# ARLINGTON COUNTY, VIRGINIA

**County Board Agenda Item  
Meeting of July 16, 2022**

**SUBJECT:** U-3468-16-1 USE PERMIT AMENDMENT for a below-grade parking structure with a lighted synthetic turf field above; located at 1601 Wilson Blvd. (The Heights Building); (RPC# 16-032-024).

**Figure 3: 18<sup>th</sup> Street North Section**

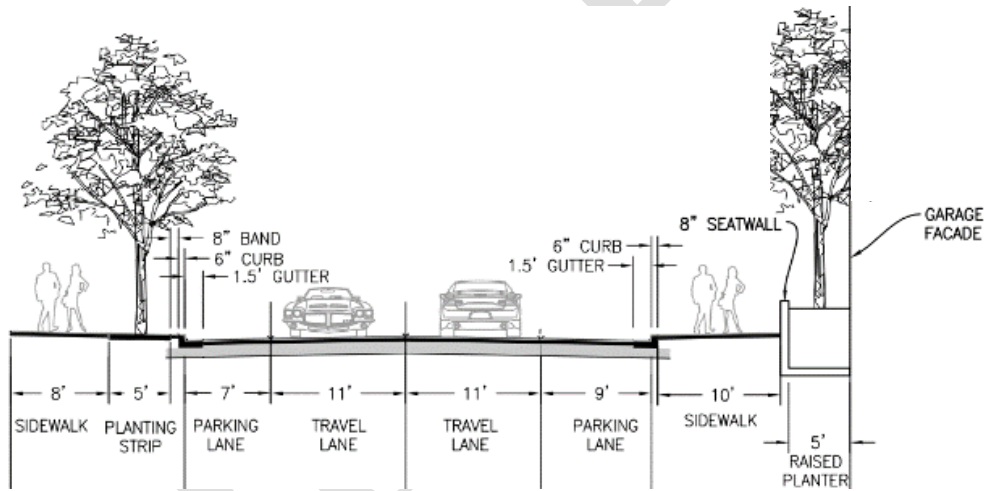
- **18<sup>th</sup> Street North Width and Parking Lane:** The applicant, Arlington Public Schools (APS) proposed to narrow 18<sup>th</sup> Street North from 38 feet to 30.5 feet, removing the southern on-street parking lane adjacent to the school property. This proposal is not consistent with the Western Rosslyn Area Plan (WRAP) recommendations, would prohibit public parking in the northern on-street parking lane, and could cause significant operational issues for APS buses.
- **18<sup>th</sup> Street North Streetscape:** APS proposed a 22-foot 8-inch-wide streetscape on the south side of 18<sup>th</sup> Street North that assumed the removal of the southern on-street parking lane described above. In keeping the existing southern on-street parking lane, the

resulting 15-foot-wide streetscape should include street trees, a 10-foot-wide minimum clear zone, and sufficient space for bus boarding/alighting.

- 18<sup>th</sup> Street North Streetscape: Within the resulting 15-foot-wide streetscape on the south side of 18<sup>th</sup> Street North, APS revised its proposal to include a five (5) foot-wide 18-inch-tall raised continuous planter with an eight (8) inch seat wall at the back of the sidewalk along the length of the garage façade with seven (7) columnar street trees and many shrubs planted throughout, two (2) additional street trees adjacent to the curb along the northwest and northeast corners of the garage, a series of decorative banners attached to the garage façade, relocation of the existing streetlights to be within the footprint of the raised planter, widening of the base of the staircase from 18<sup>th</sup> Street North to the field, maintenance of a 10-foot-wide minimum clear zone adjacent to a six (6) inch curb for pedestrian movement and provision of space for school bus boarding/alighting.

As revised, the proposed streetscape on the south side of 18<sup>th</sup> Street North is consistent with the WRAP which depicts a 2.5-foot curb and lighting zone, a 10-foot-wide sidewalk, and an optional width for street trees along the back of sidewalk. The raised continuous planter provides sufficient soil volume and spacing for the seven (7) columnar street trees and shrubs. By integrating street lighting within the footprint of the raised planter at the back of sidewalk, a 10-foot-wide clear zone adjacent to a six (6) inch curb is provided for pedestrian movement and space for bus boarding/alighting. Staff supports this revision as it is generally consistent with the WRAP guidelines, provides street trees, incorporates seating for students during arrival and dismissal, integrates decorative banners to assist in screening the adverse visual impacts of the parking garage, and maintains a minimum 10-foot-wide clear zone on 18<sup>th</sup> Street North.

**Figure 4: Landscape Plan**

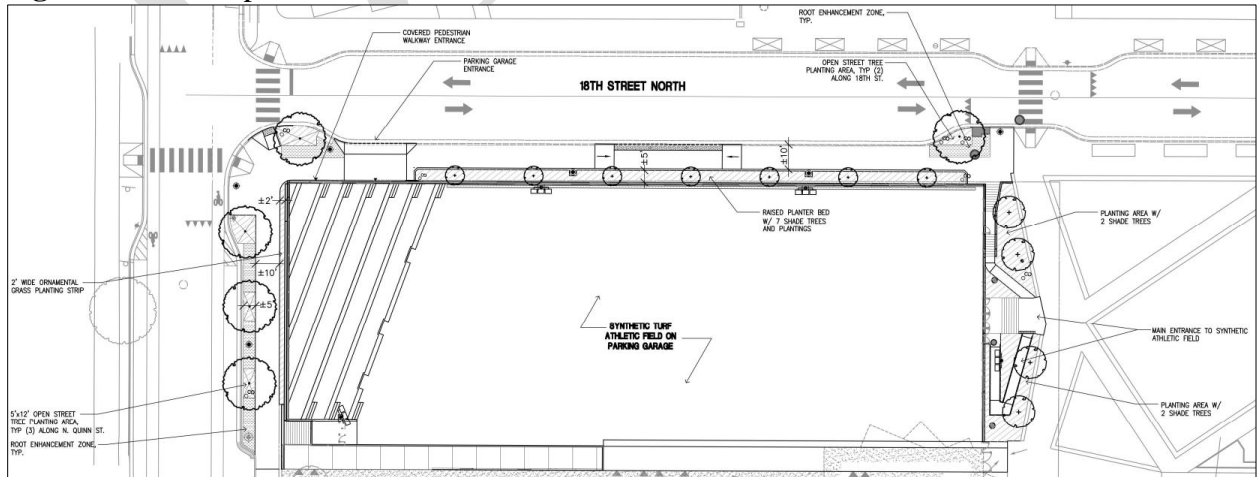
Additionally, along North Quinn Street, APS proposes a two (2) foot-wide planter strip against the railing along the back of the sidewalk to add visual interest to the sidewalk and Shriver Program entrance. APS also proposes two (2) additional trees in the planting area along the east side of the field adjacent to Rosslyn Highlands Park.
